No. EL/3.2.182

Modification Sheet No. RDSO/2017/EL/MS/ 0466 (Rev '0') Dated 15.11.2017

Modification in drawing of Outer bearing cap DE to achieve adequate lateral thrust in Traction motor (TM) assembly of 6FRA6068 TM in WAG9/ WAP7 class of locomotives.

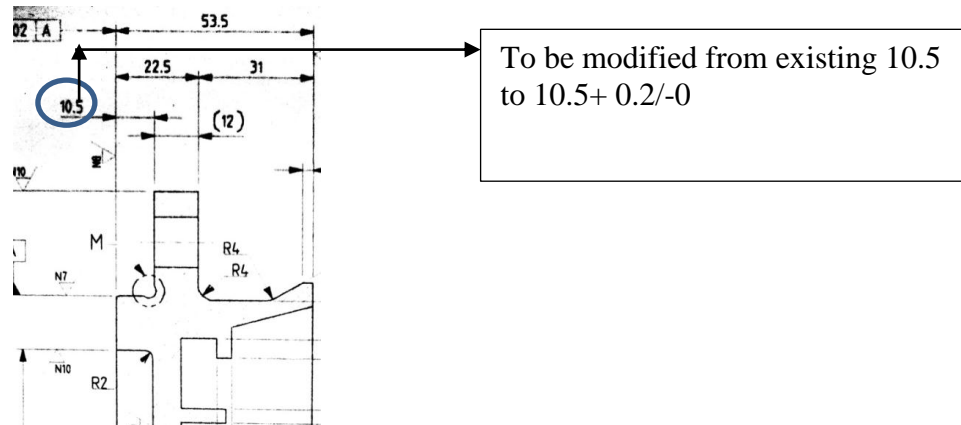
The Range of Clearance /Gap between outer face of end shield (DE) and inner face of outer bearing cap DE = $(B+C+D)-A$

Minimum Clearance/Gap = $(4.95+10.30+85.75)-101.00 = \mathbf{0.00}$

Maximum Clearance/Gap = $(5.05+10.70+86)-100.80 = \mathbf{0.95}$

3.1.5. From the above calculations, it is observed that the clearance between outer face of end shield and inner face of outer bearing cap DE is $0.5 +0.45/-0.5$ mm due to manufacturing tolerances of various components. Thus, the value of this clearance is $0.5 +0.45/-0.5$ mm, with range from 0.00 mm to 0.95 mm. If this clearance is not available, it will cause inadequate lateral thrust on the outer racer of the DE bearing

3.1.6. To ensure adequate lateral thrust, it is decided to increase this clearance by changing the dimension of step of Outer Bearing Cap DE from 10.5 mm to $10.5 +0.2/-0$ mm. For this, CLW had been advised vide letter no. EL/3.2.182 dated 26.05.2017 to modify the drawing No. 1TWD.096.006 Alt. 4 as shown below :

3.1.7. With this proposed modification, the clearance between outer face of end shield and inner face of outer bearing cap DE will be $0.5 +0.45/-0.3$ i.e. from 0.20 mm to 0.95 mm, which will ensure adequate lateral thrust and improve the reliability of the DE bearing of TM type 6FRA6068TM.

CLW Drawing No. 1TWD.096.006 Alt '6'.

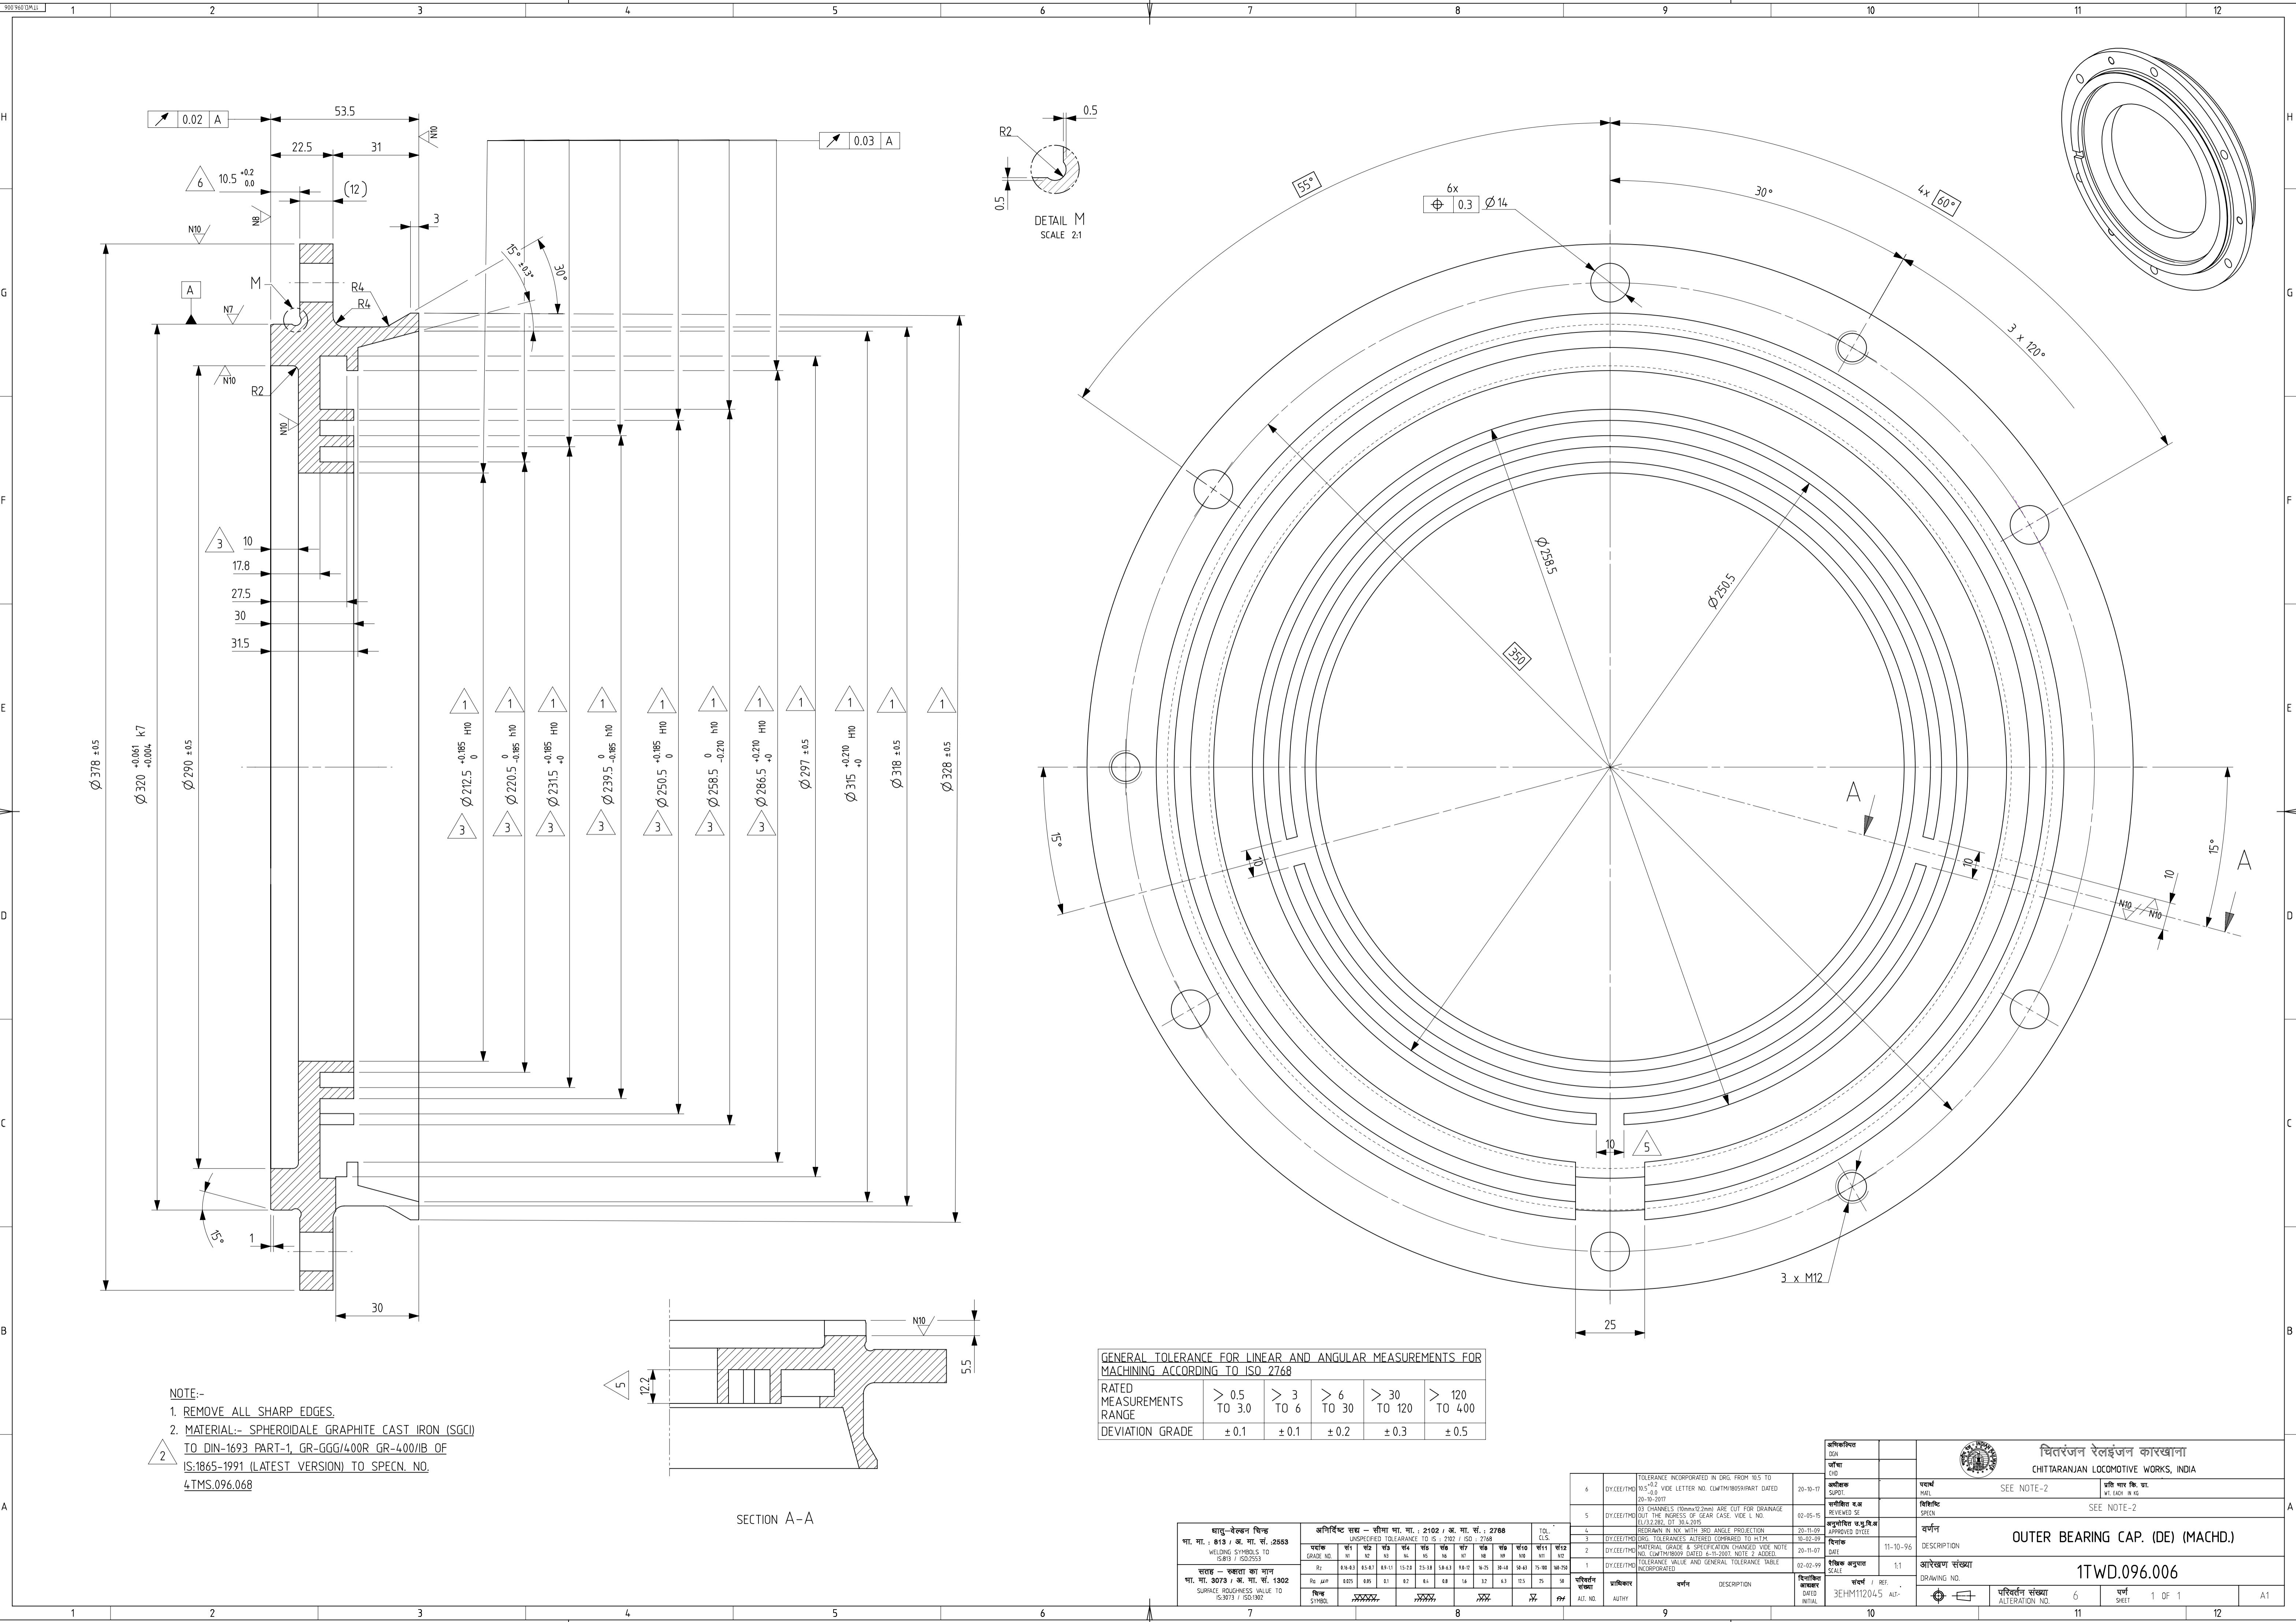
3.1.8. CLW had modified the drawing accordingly and issued modified drawing no. 1TWD.096.006 Alt. 6 vide letter number CLW/TM/18059/Part dated 28.10.2017.

- 4.1. Description of kit of labyrinths for TM type 6FRA-6068 shall be modified to include modified drawing of Outer Bearing Cap DE i.e. Drawing Number 1TWD.096.006 Alt. 6 for future procurement.
- 4.2. During the assembly of Traction motor, Outer Bearing Cap DE as per Drawing No. 1TWD.096.006 Alt'6'(or latest) to be used.
